Agenda
City of Springboro Planning Commission Meeting
Wednesday, March 13, 2024, 6:00 p.m.
Council Chambers, City Building, 320 West Central Avenue

Record Plan, Village Park PUD-MU, Planned Unit Development-Mixed Use, office component, replat of Clearcreek Township Fire Station #24 site

Site Plan Review, southwest terminus of West Tech Boulevard, new building for Caesar Creek Software

Final Development Plan, 1525 South Main Street (SR 741), Northampton PUD-R, Planned Unit Development-Residential, residential subdivision

- STORMWATER MANAGEMENT BASIN
- OPEN SPACE MAINTAINED BY HOA
- PROPOSED WALKING PATH
- PROPERTY LIMITS

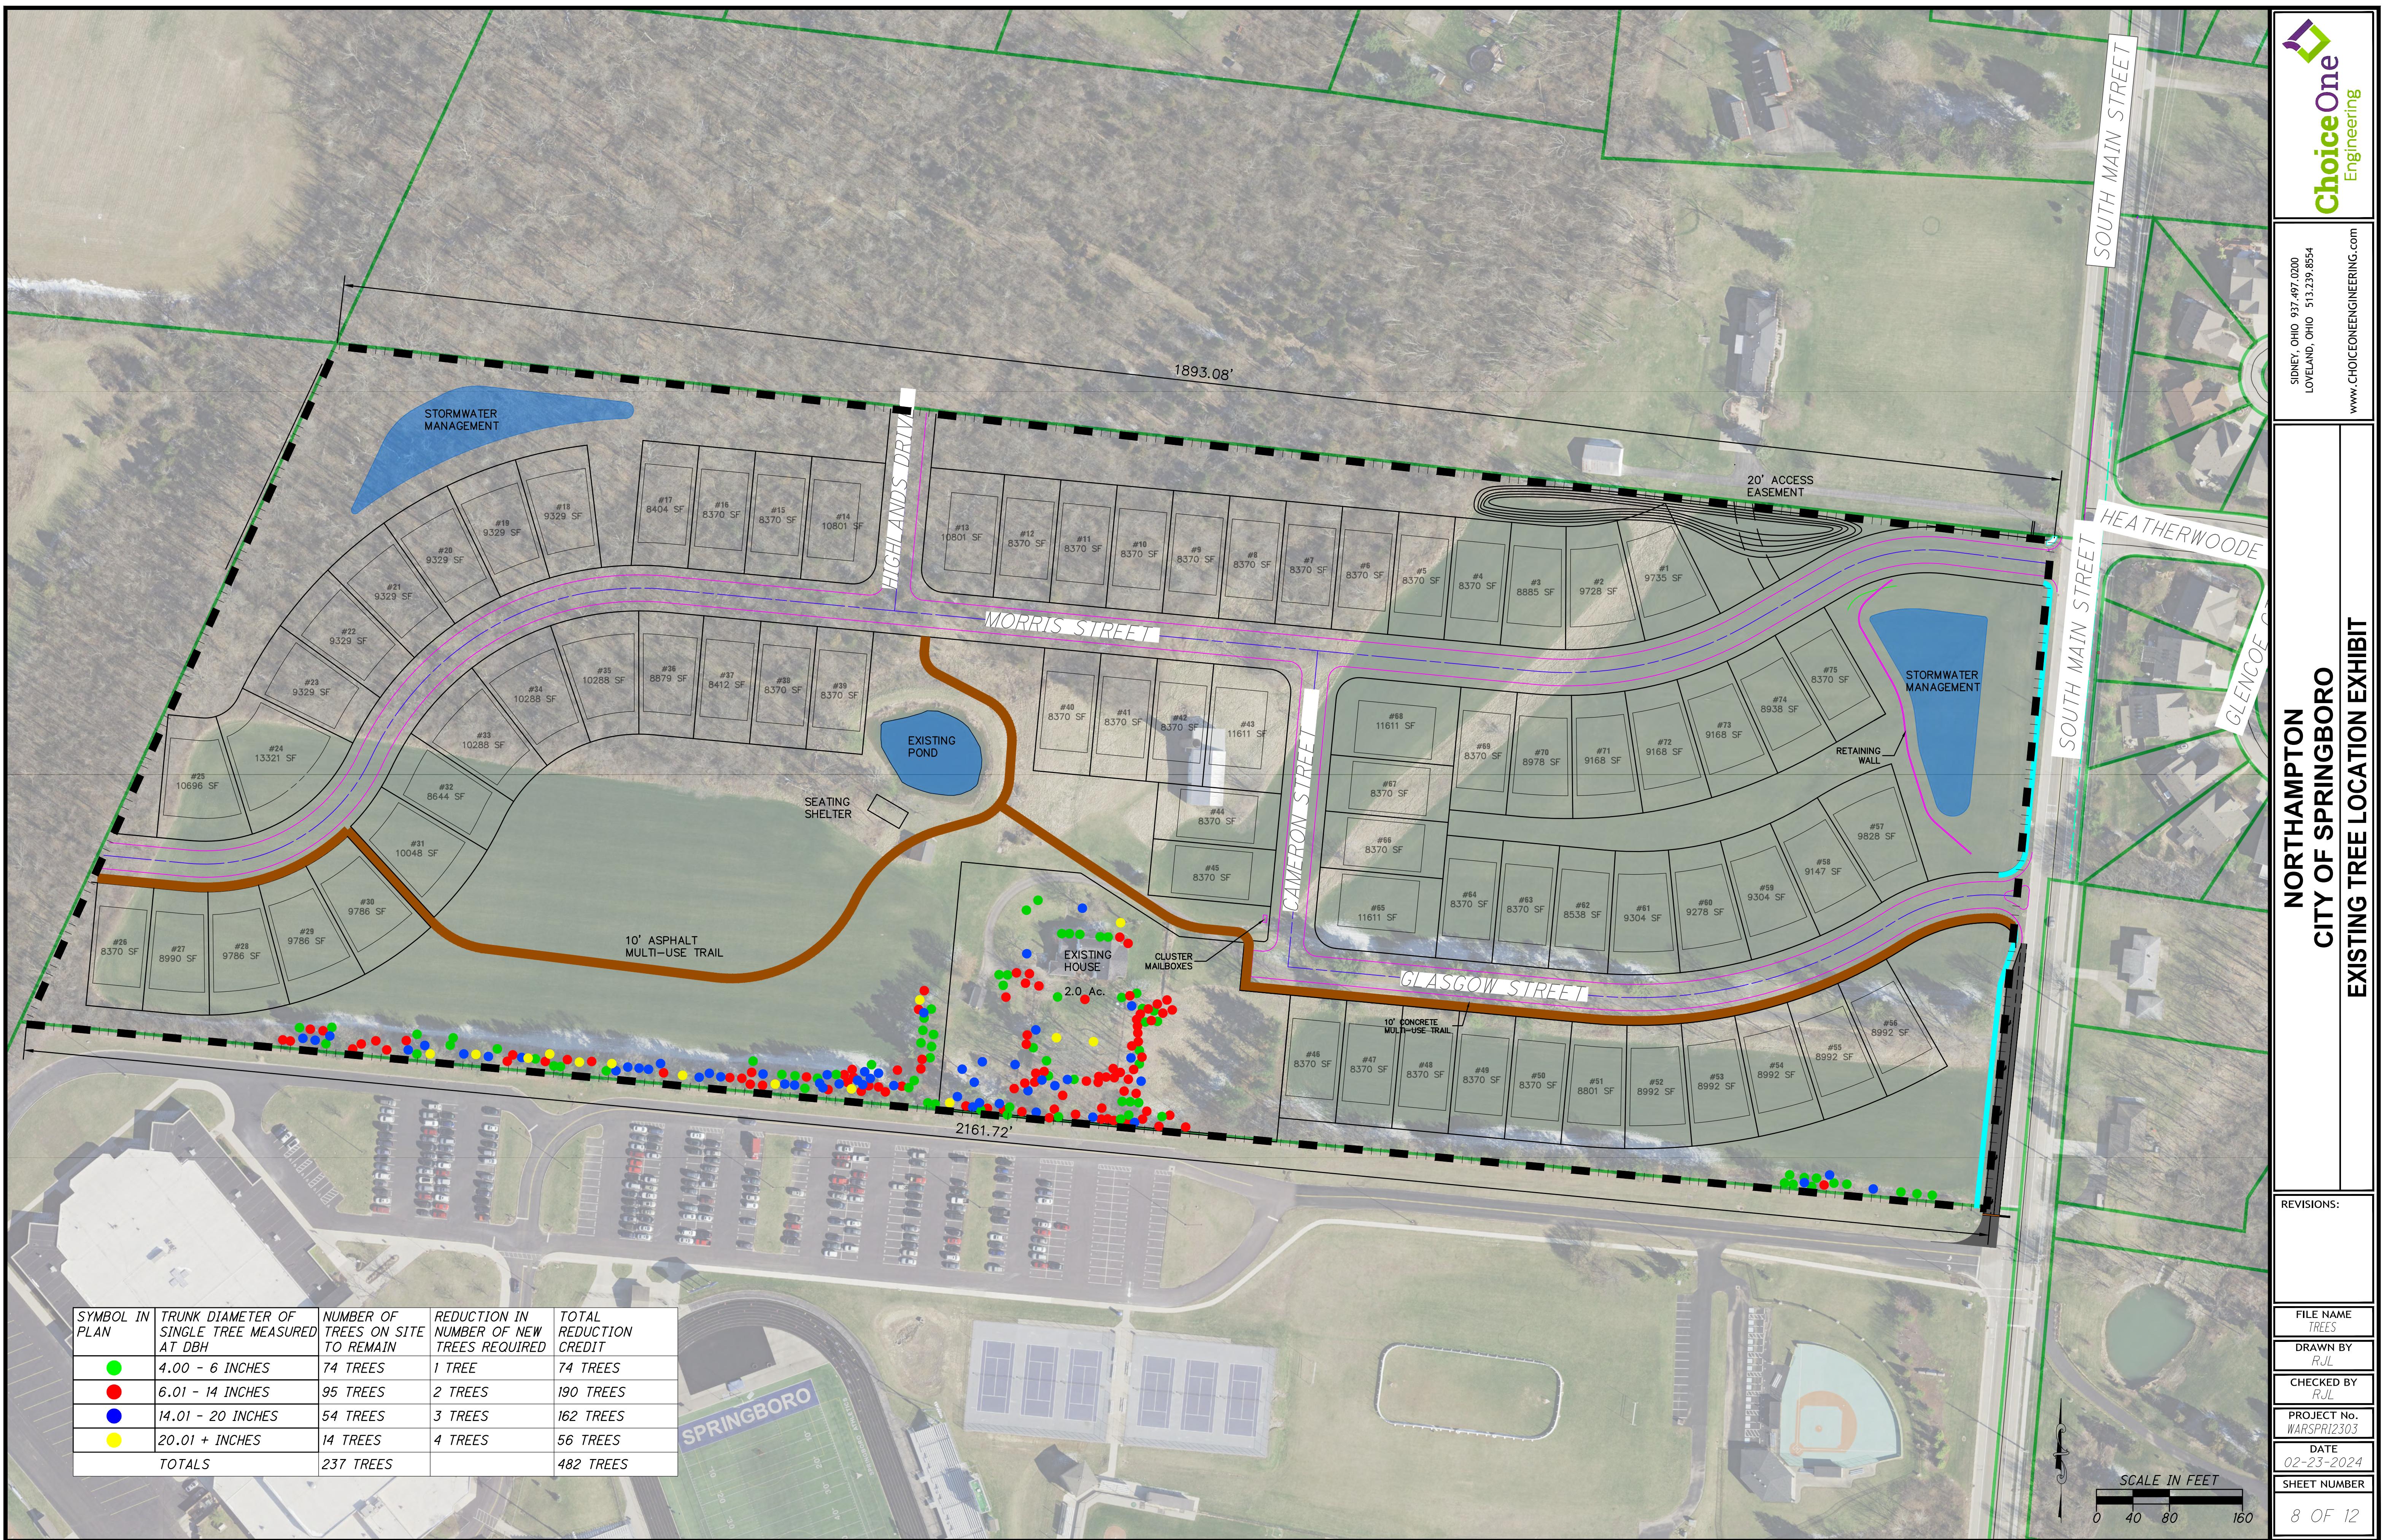
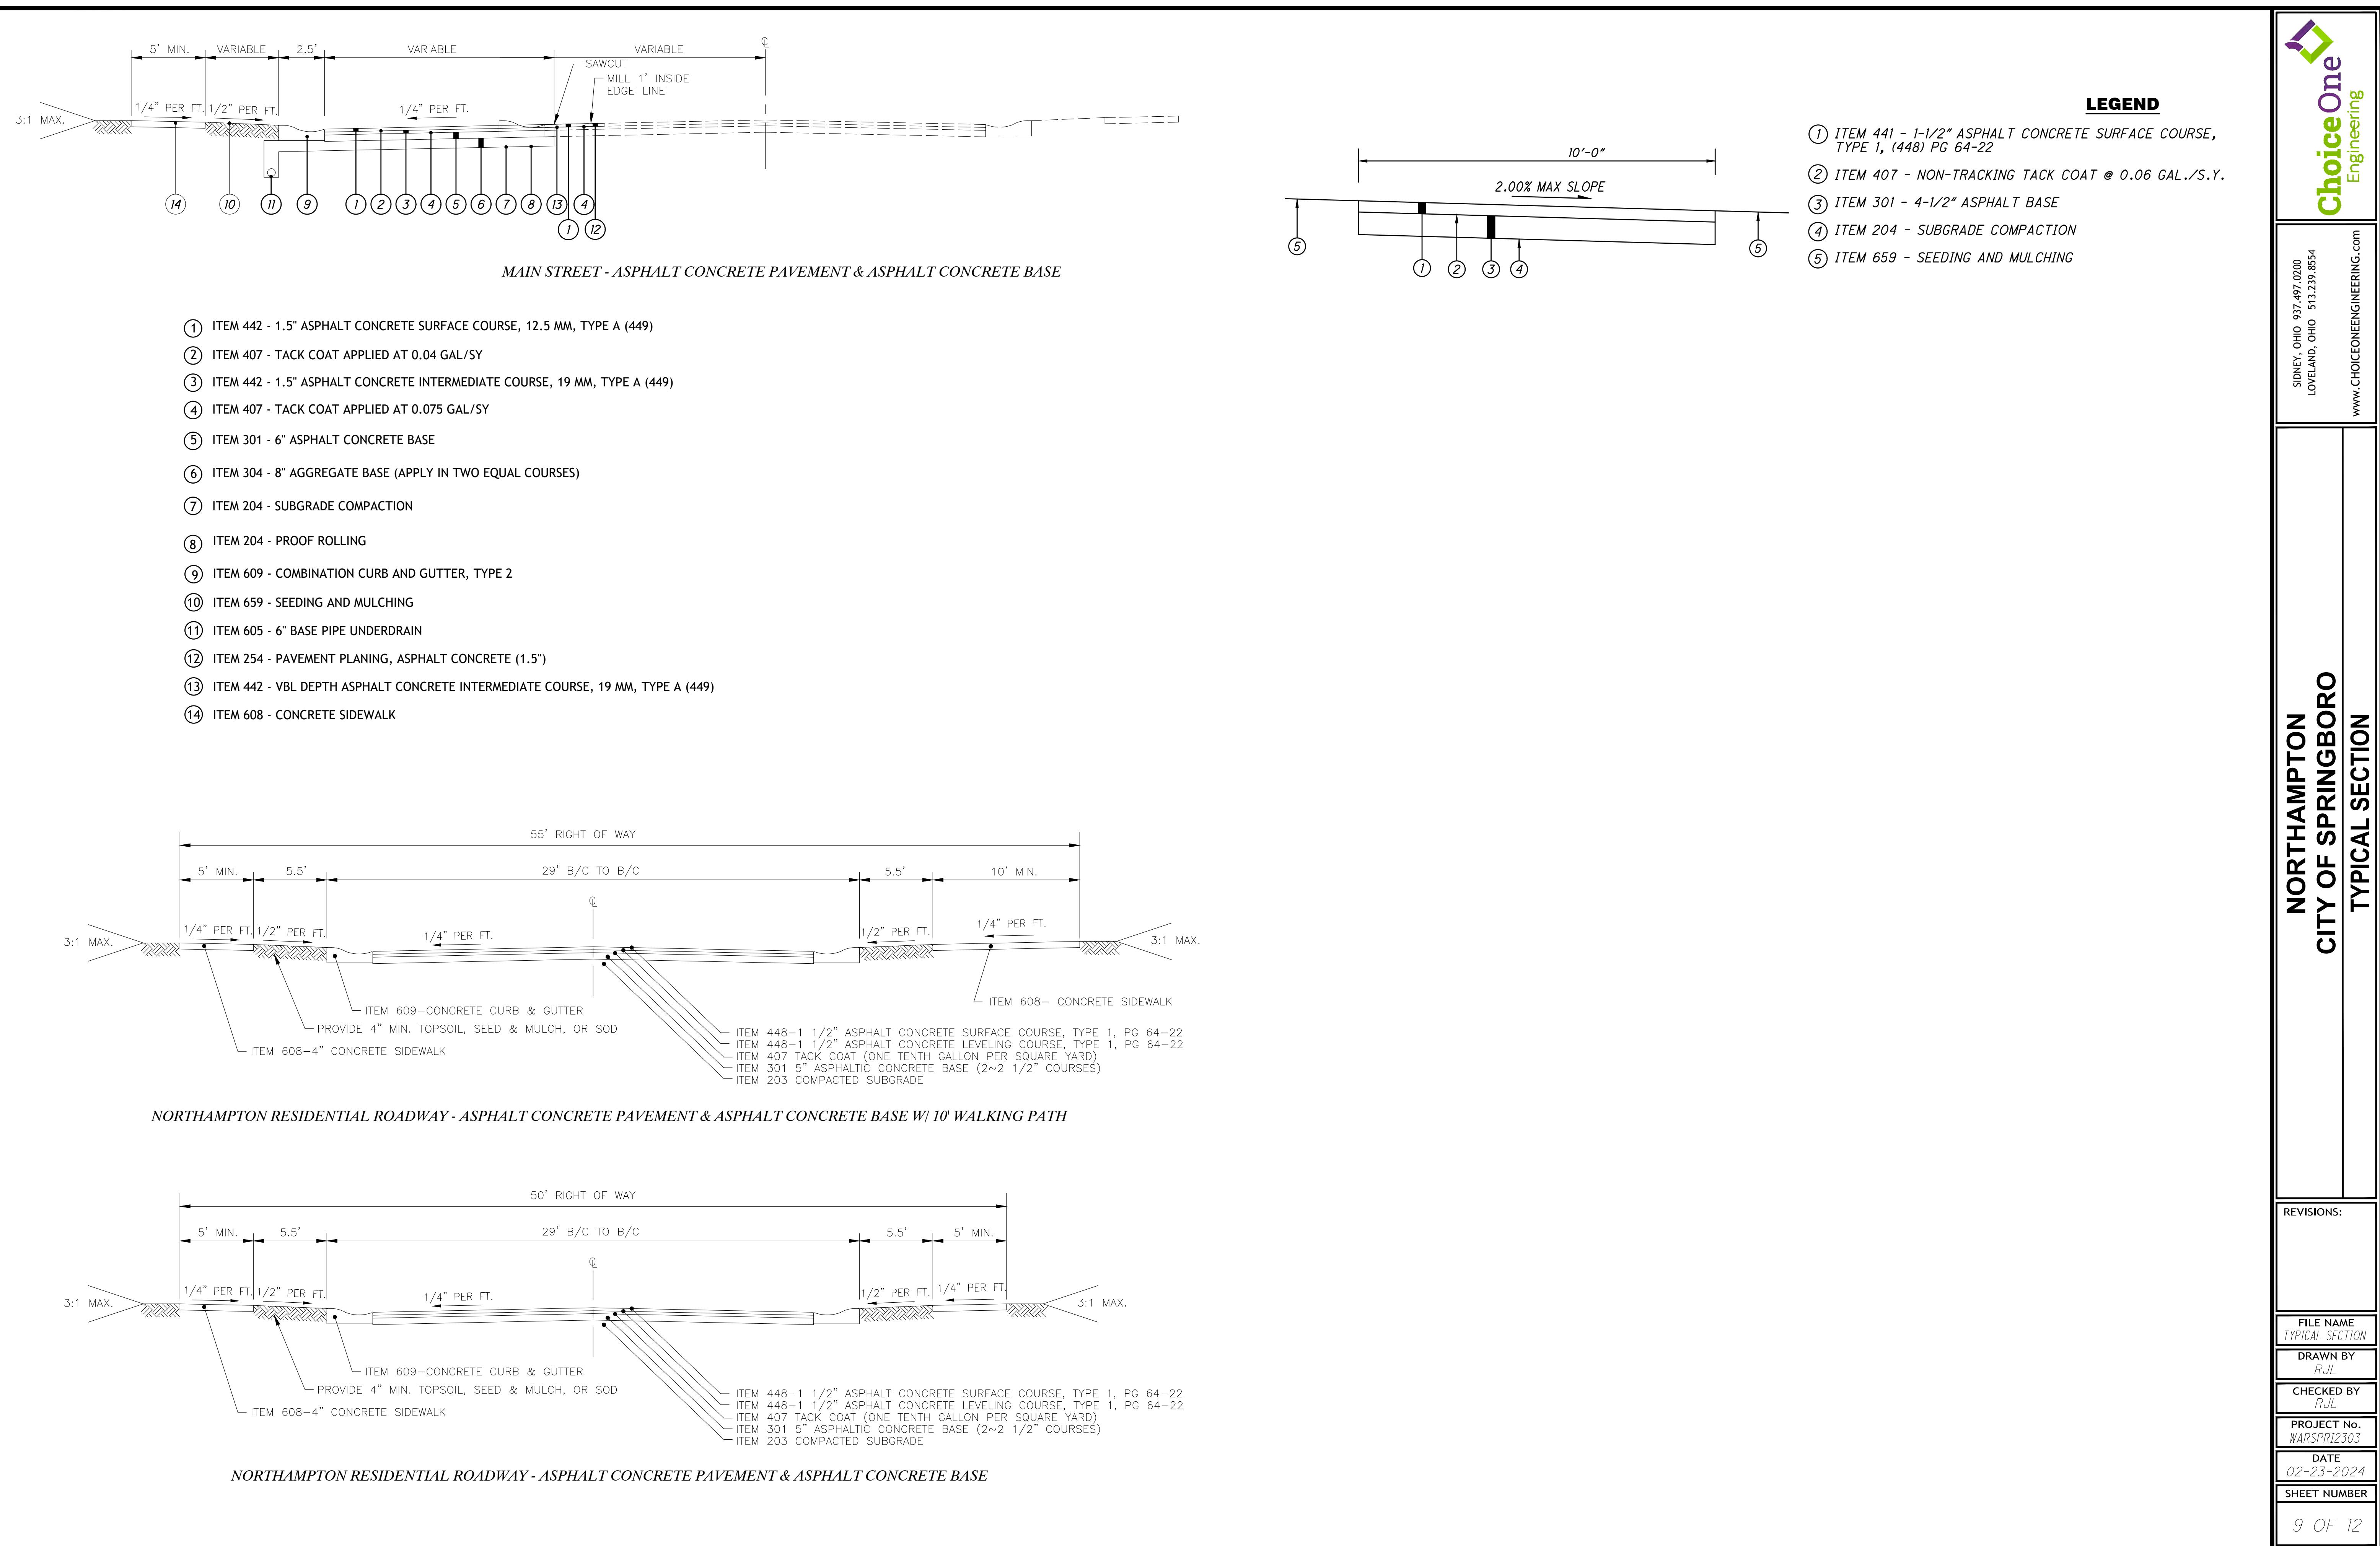
1. Check open space information provided on sheet 4 of 12; total is less than approved general plan, and the numbers do not add up correctly.
2. All homes to be consistent with Section 1264.06, Development Standards for Specific Uses, Single-Family Dwellings (Detached) for compliance of some of the home plans with (b) Appearance, and (c) Garages with respect to 60% maximum width and side/rear access.
3. Landscaping plan information needs to be updated as follows to assist in staff's review under Chapter 1280, Landscaping, of the Planning and Zoning Code:
 - a. Indicate how required buffers are to be memorialized and maintained.

- 16. Is the fence on the south property line remaining in place?
- 17. Provide minimum dwelling unit floor area and minimum lot size (change from typical) and delete average lot on general plan sheet 4 of 12.

PLANTING SCHEDULE

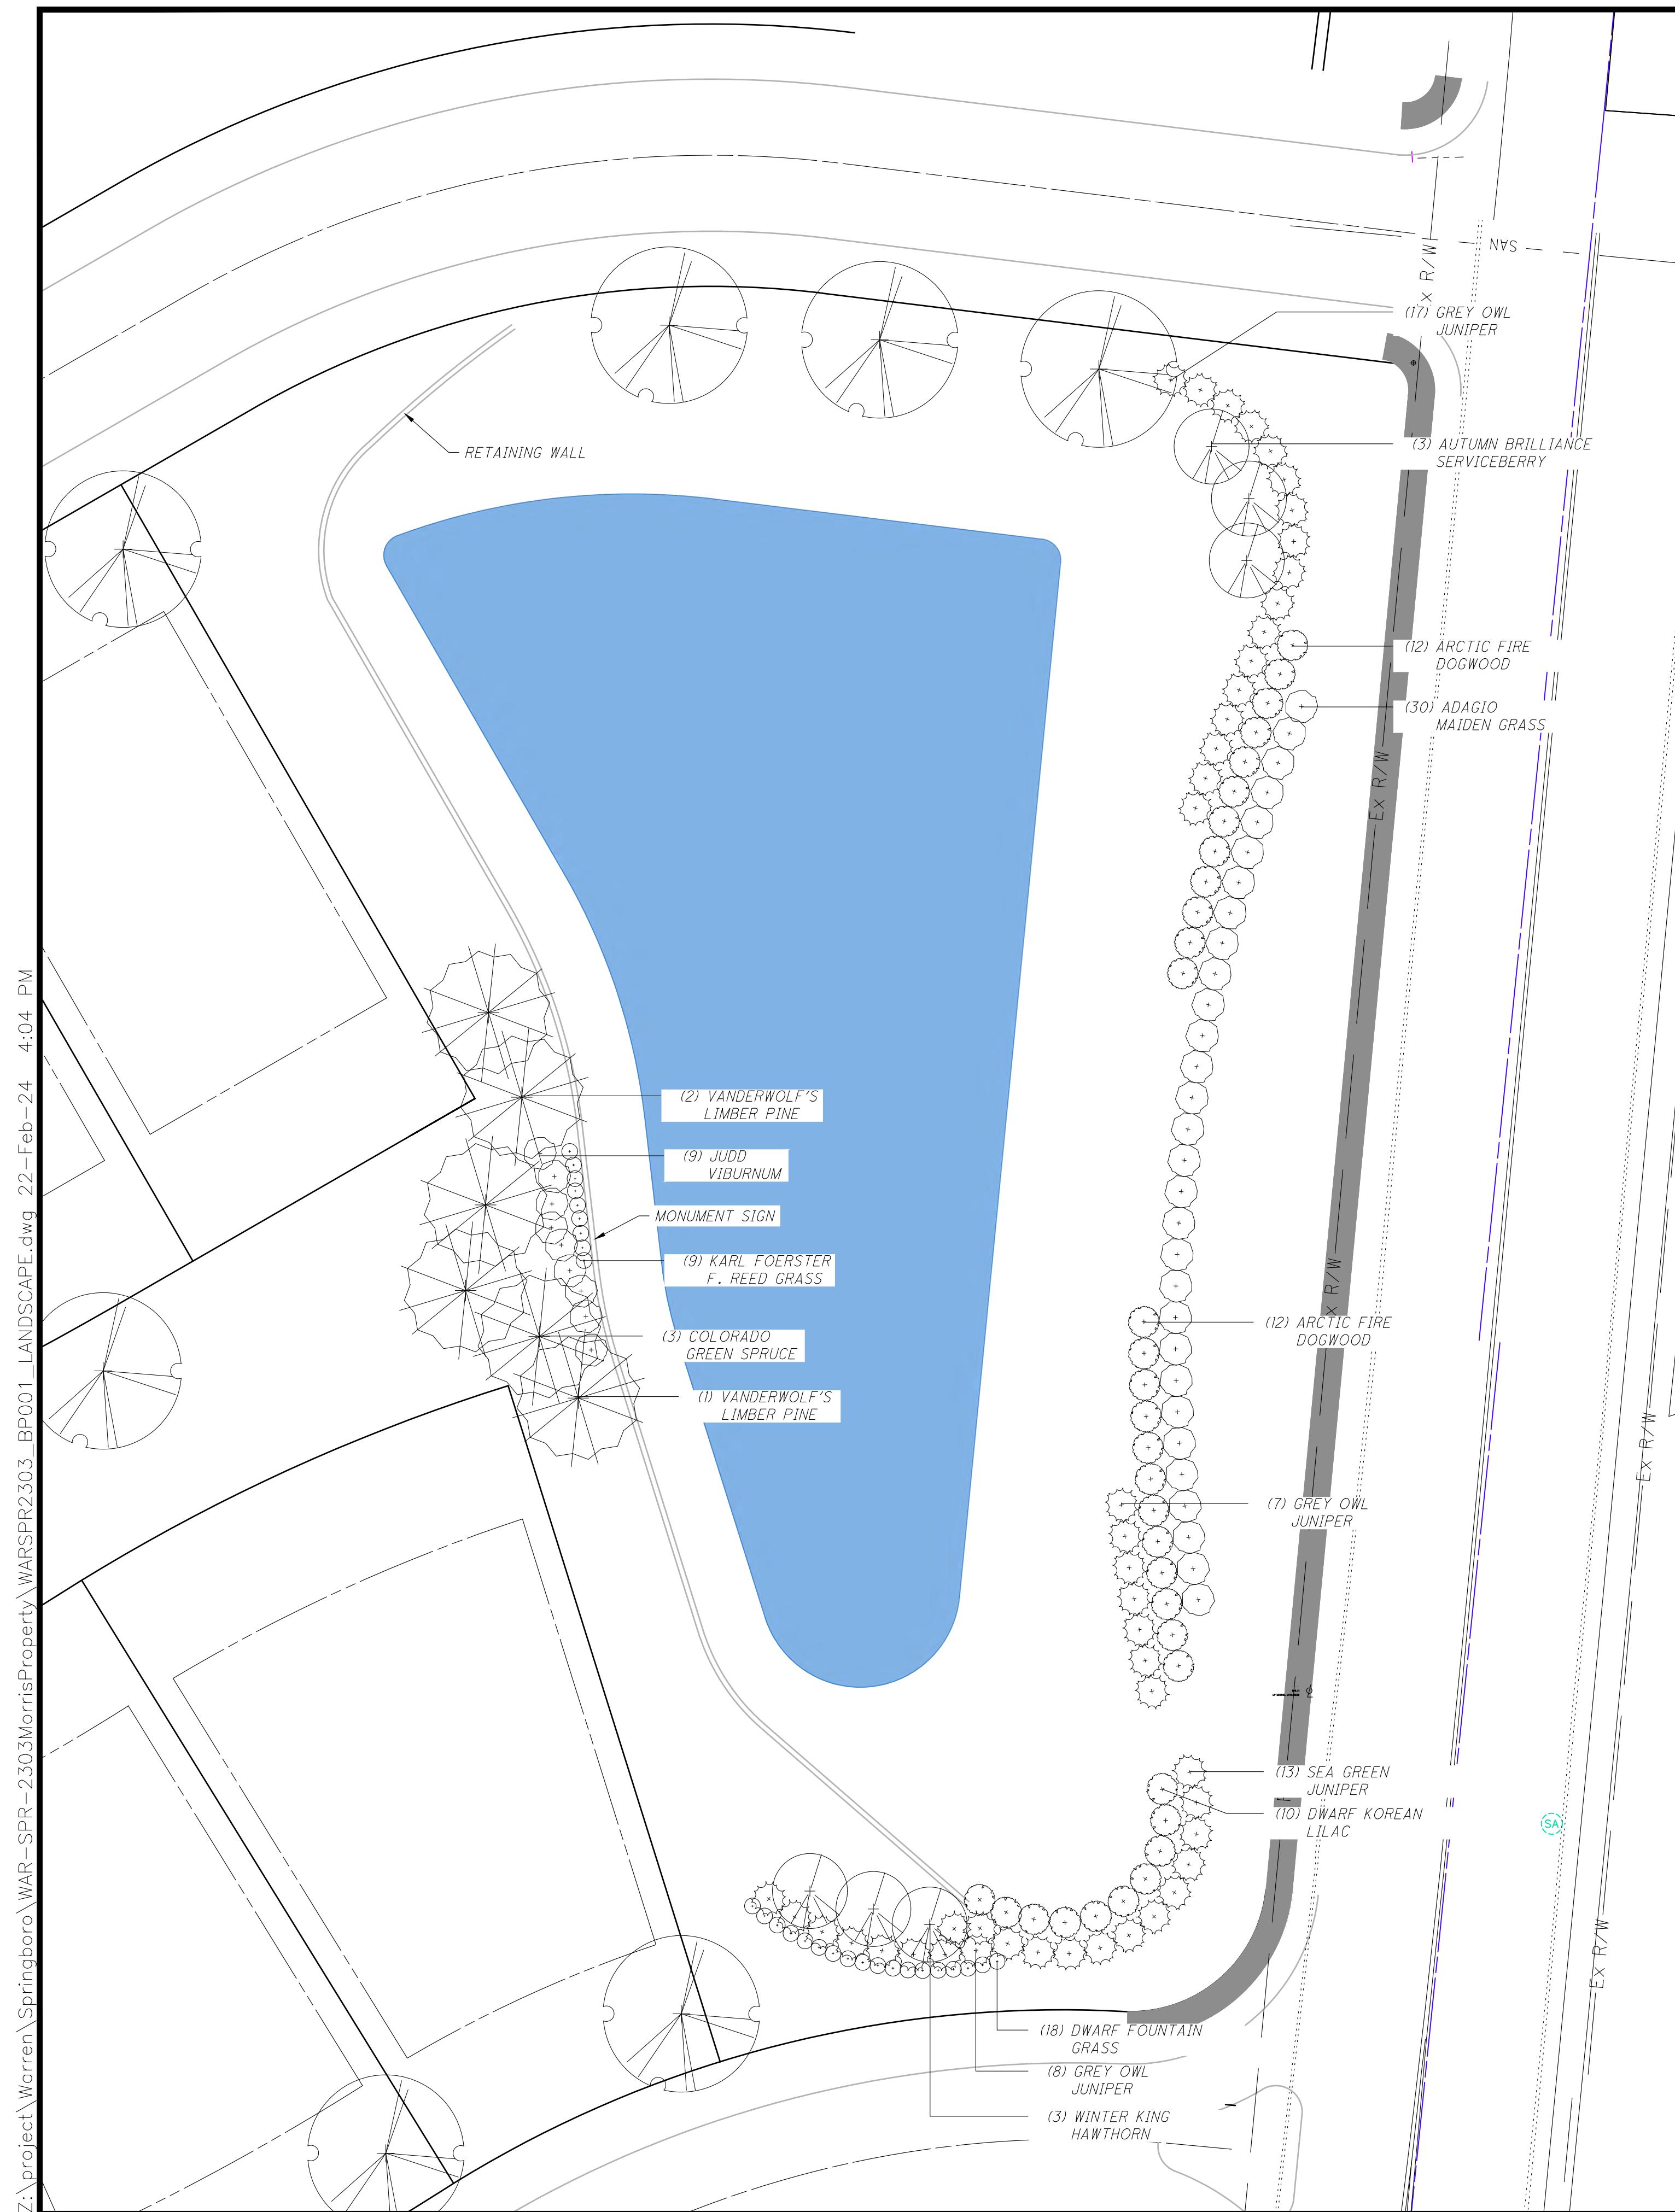
- c. Confirm that proposed color-temperature of exterior lighting is 3500 Kelvin or less.
4. Landscaping plan to be revised to provide additional trees on the West Tech Boulevard frontage, and foundation plantings adjacent to the building.
